COUNTY OF FRESNO
CONSTRUCTION MANAGEMENT
CONTRACT CHANGE ORDER

FRESNO COUNTY WESTSIDE GROUNDWATER PROJECT
EL PORVENIR (CSA 30) & CANTUA CREEK (CSA 32)
PILOT HOLE TESTING AND PRODUCTION WELL CONSTRUCTION
DRINKING WATER STATE REVOLVING FUND
PROJECT NO: 1000359-005C
CONTRACT NO. 18-07-C

CHANGE ORDER NO. 9
JANUARY 30, 2025
PAGE 1 OF 3

PERFORM VARIOUS EXTRA WORK

SHEET NO. E13 OF 14

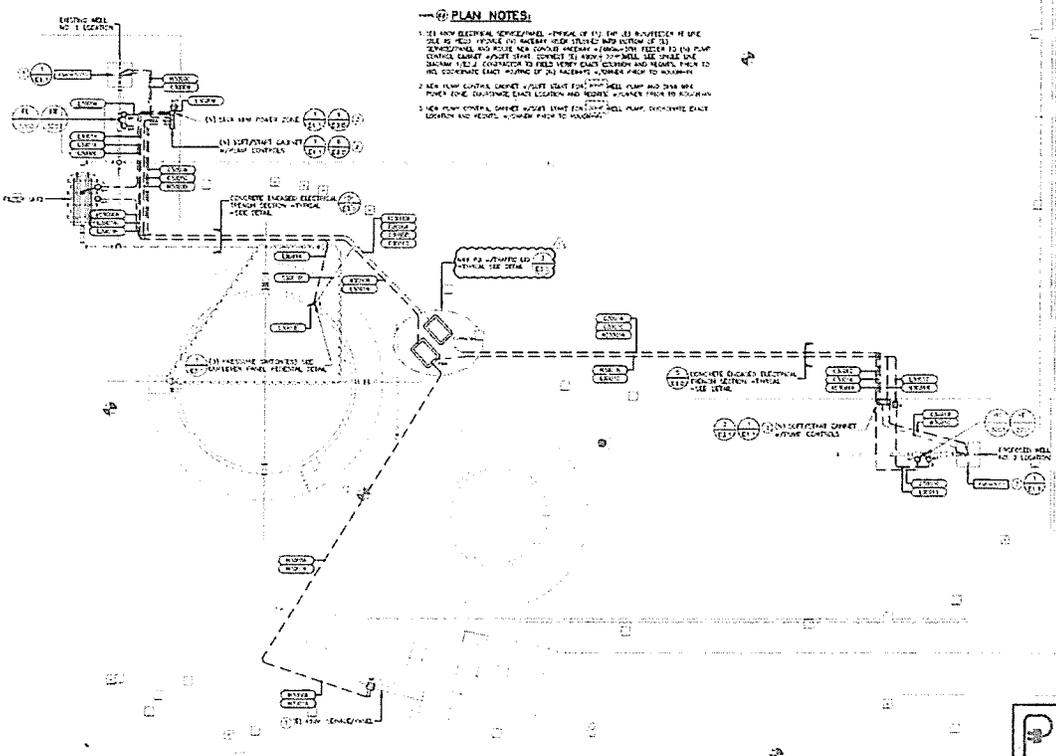
Zim Industries, Inc. proposes a change order for electrical design modifications, consisting of larger horsepower soft starters and larger wire sizes. These modifications were required to suite the new pump equipment designs and are reflected in the following updates:

- 4/26/2022: CSA 32 pump specifications revised, upgrading motors from 40 HP to 50 HP.
- 9/1/2022: CSA 30 pump specifications revised, upgrading motors from 20 HP to 30 HP.
- 6/29/2023: CSA 30 wire sizes increased from #4 to #1, per response to the pump submittals.
- 1/28/2024: CSA 30 wire size increases confirmed, per response to RFI #4.
- 2/28/2024: CSA 32 wire sizes increased from #1/0 to #2/0 and CSA 30 wire sizes confirmed, per RFI #5 response.
- 3/25/2024: No further wire size changes, per response to RFI #6.

Attached is documentation from our electrical subcontractor and their supplier outlining the cost implications, as well as the updates provided above and the revised plan and specification sheets reflecting these modifications. Including bond cost and a 15% markup, our proposal for these modifications amounts to \$10,480.70.
